14 December 2018

**RE: Proposed S4.55(1a) Application for the Modification of Consent for SSD8019 for Amendments to the Floor Plans for Mixed Use Development**

**Our Ref: 18307**

**Figure 3 – Approved northern elevation**

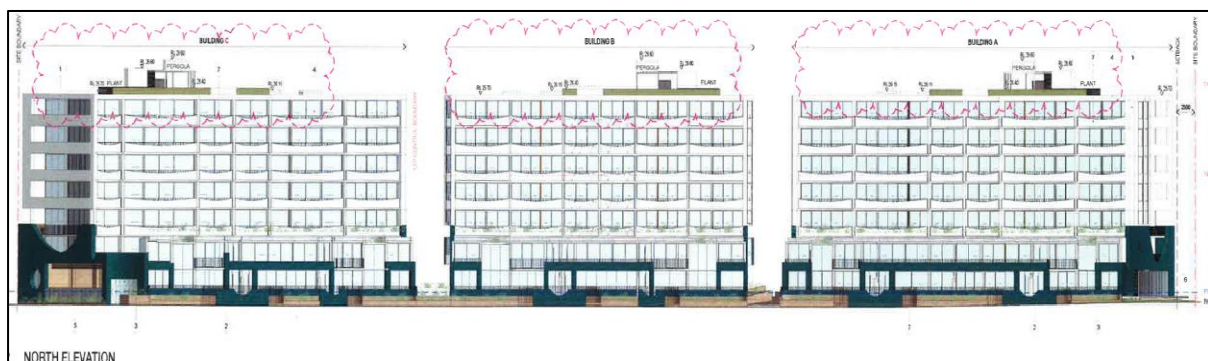
Changes to the roof structure relating to parapet and re-position of the mechanical condensers from the roof slab to sit on plant platforms on the roof as a result of design finalisation. The following approximate changes are proposed

- a) Height of rooftop plant has increased by 1050mm.
- b) Parapet has increased by 300mm.
- c) Planters have increased in height by 250mm.
- d) Lift overrun has decreased in height by 200mm based on lift design
- e) Level 2 terrace roof increased by 200mm

The minor changes proposed to the elevations of the building relating to the height of the parapets, plant items and lift overruns have come as a result of further finalisation of the design. The changes are minor in context to the building as a whole. The parapets on the northern side of the builds have increased in height by approximately 265mm. The planter boxes have increased in height by approximately 200mm, and the lift overruns have decreased in height by approximately 250mm.

Below are elevations that show the proposed changes.

Figure 6 – FPL and PMF levels for Honeysuckle Drive

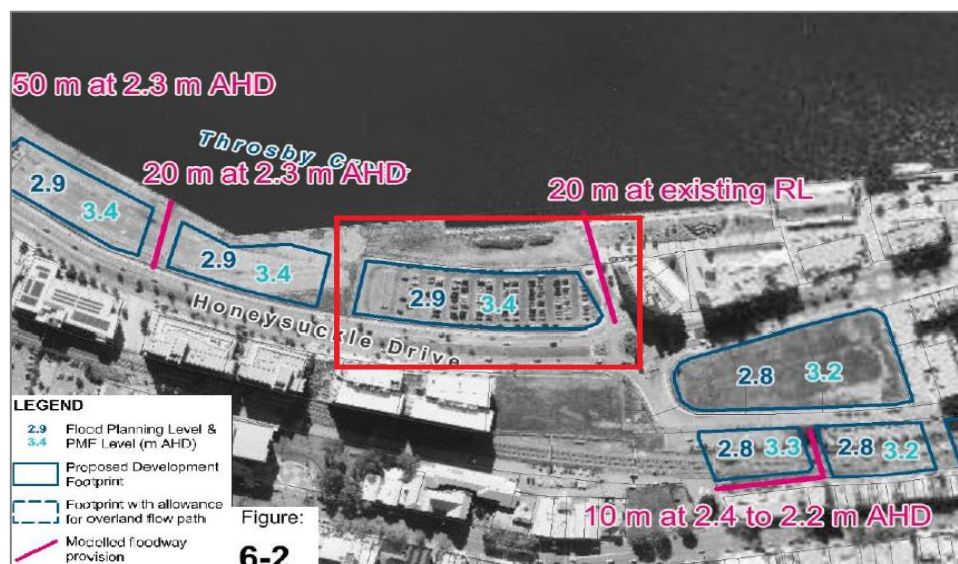
The Honeysuckle Redevelopment Area Flood Study prepared by BMT was revised on the 8 of March 2018 and provided further investigations relating to the PMF levels of sites at Honeysuckle. Figure 6-2 of the attached report in Appendix 2 notes that the new PML level for the development shown at 21 Honeysuckle drive is now 3.4m AHD and the Flood Planning Level now being 2.9m AHD. Figure 6 below is an excerpt from the Flood Study, specifically figure 6-2 of the report which indicates the updated levels.

As the study has been updated the conditions which were drafted based on the previous version of the study should be updated to reflect the latest version of the report.

- B23 On site refuge is to be provided for the proposed development. The minimum refuge level is to be the level of the PMF (Local Catchment Flood Level ~~RL3.65m~~ **RL3.4m** Australian Height Datum). On site refuge is to be designed to cater for the number of people reasonably expected to be on the development site. Openings such as exhaust ducts, car park air intake, vents and the like that could potentially allow for flood waters to enter the basement (except for carpark and access) are to be designed at minimum RL3.65m AHO. Full details are to be included in documentation for a Construction Certificate application.

- B24 The whole of the proposed structure below known probable maximum flood planning level (~~RL3.65m~~) (**RL3.4m**) is to be constructed in materials and finishes that are resistant to damage from floodwaters. Any new machinery or equipment, electrical circuitry or fitting, storage unit or similar items likely to be damaged by floodwaters being installed above the PMF level or alternatively being of materials and functional capability resistant to the effects of floodwaters. Full details are to be included in documentation for a Construction Certificate application.
